ADVICE

To	Chris Anderson, Francis Construction
Mode of transmission	Via email as PDF
Date	29.10.20
Instruction	Broad oak Place
FLAC Instruction ref	CC31-1036
Client	Francis Construction
Subject	Breach of condition (approved Tree Protection Plan)

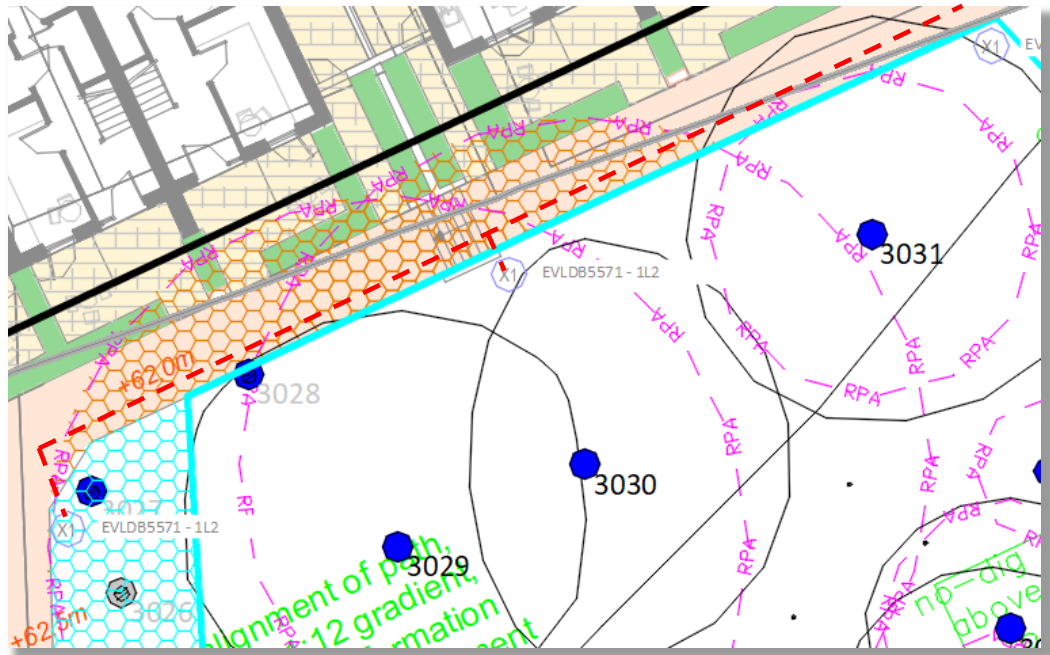
6. The marked-up *Tree Protection Plan* extract at Figure 2 below demonstrates the drainage trench has severed a chord on the north side of the RPAs of 3029 and 3030. This area was specified on the TPP to be protected initially by a combination of tree protection barriers in combination with temporary ground protection during construction, the latter to be replaced by a no-dig permanent surface thereafter, the objective being to avoid intrusions below ground level to safeguard roots for ongoing tree health and stability.

Figure 4. Common trench to north of tree protection fence within RPAs of 3029 and 3030, shows spur to lamp column opposite 3030 being installed

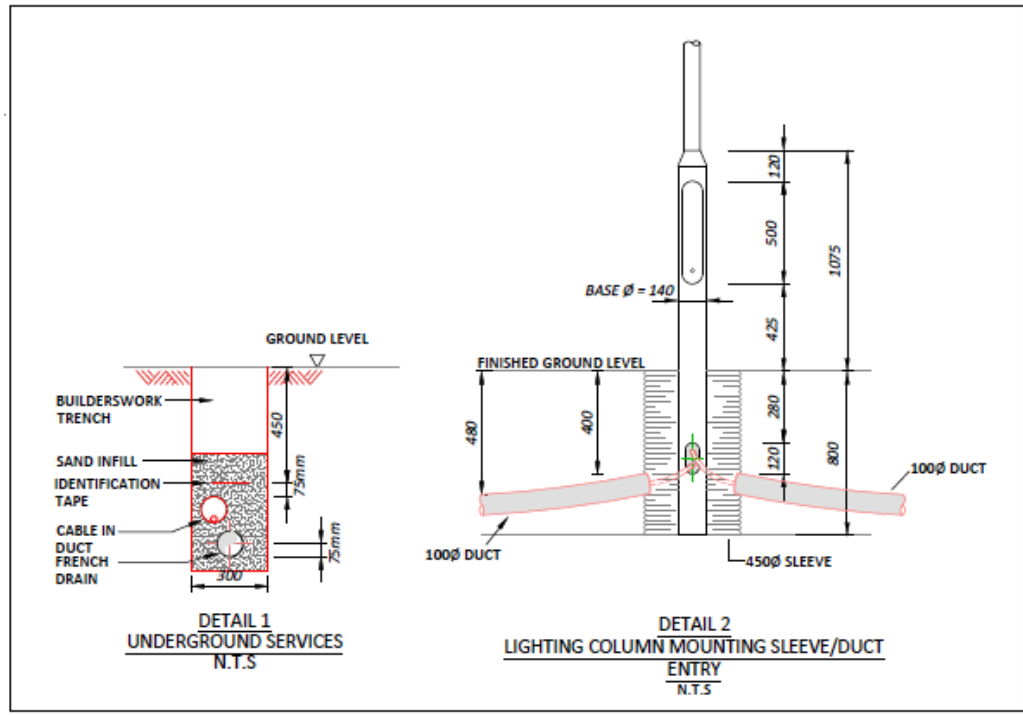
7. The photograph at Figure 4 below (and appended also at larger scale) shows the trench works at time of construction, in relation to the tree protection fencing. We understand that the excavations took place greater than one year ago, accordingly, subterranean investigations would risk further disturbance to existing or potentially regrown roots. By assessment of the photograph no significant roots can be seen on the tree side of the trench.

8. Of course, there are limitations to any conclusions that can be drawn from the Fig. 4 photograph including that it does not fully show the section opposite 3029. However, no significant roots are visible in the photograph and it is our experience of photographing subterranean investigations near to trees that ordinarily where roots are present they can be seen, including roots smaller than 25mm in diameter.
9. We have reviewed the topographical survey prepared prior to redevelopment to learn what we can about the pre-existing site conditions and whether the previous situation may have affected root distribution within the area of disturbance. Figure 5 below depicts an extract of the topo with the FLAC ids. 3029, 3030 and 3031 overlaid including their RPAs.

Figure 7. Plan extract from FLAC Planning Submission material (2015) to show positions of former trees in relation to 3029

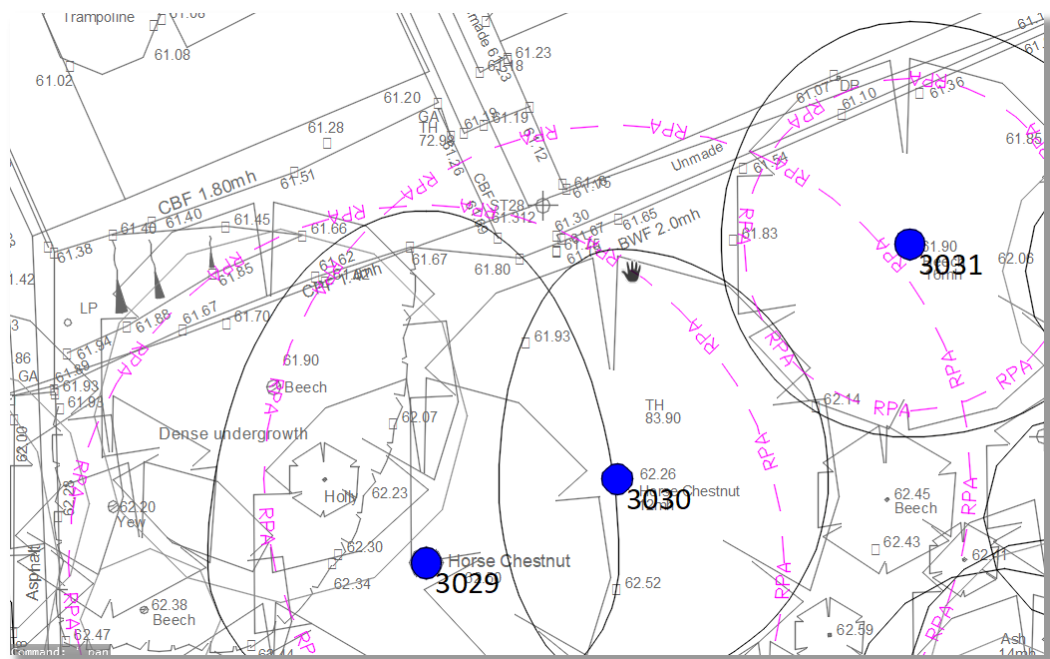
11. We have reviewed our 2015 Planning Submission material, which at its drawing entitled *Tree Survey, Retention & Removal Proposals + Layout* FLAC Drwg No. 31-1036.05-A (see extract at Figure 7 below) shows the previous tree presence in this area.

12. The drawing extract shows the locations of former trees felled to facilitate development FLAC identifies. 3026, 3027 and 3028 at west to north RPA quadrant. It is possible that roots of these former trees may have dominated the soil such that it was less attractive for root colonization of this area by roots from 3029 due to the inevitable competition for water and nutrients. However, this might only mean that the horse chestnut dispersed fewer roots here rather than no roots.

Figure 9. Red line our mark-up to show land drain discharge into west RPA periphery

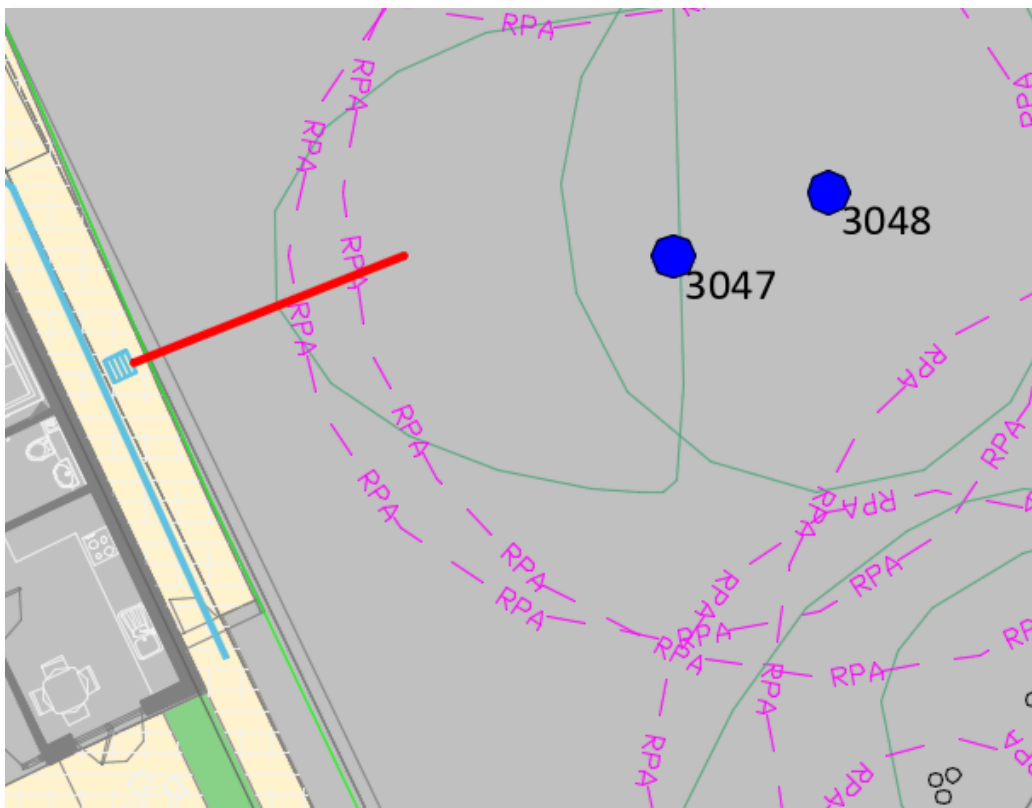
15. The land drain terminates ca. 5.1 metres west of stem centre of 3047, its alignment enters the periphery of the RPAs radially (see marked-up plan extract Figure 9 below). This feature appears to be formed predominantly, if not wholly, within recently made (raised) ground such that it may sit above pre-existing ground levels and intrusion below ground level is thought to be minimal (topo survey does not provide levels for this off site area). Whilst no ill-effects are evident currently, the council may have views on discharge of land drainage into the off site wooded area.

16. We do not anticipate significant disturbance has occurred to 3047 or 3048. No arboricultural mitigation is proposed beyond a schedule of re-assessment of condition as set out below.
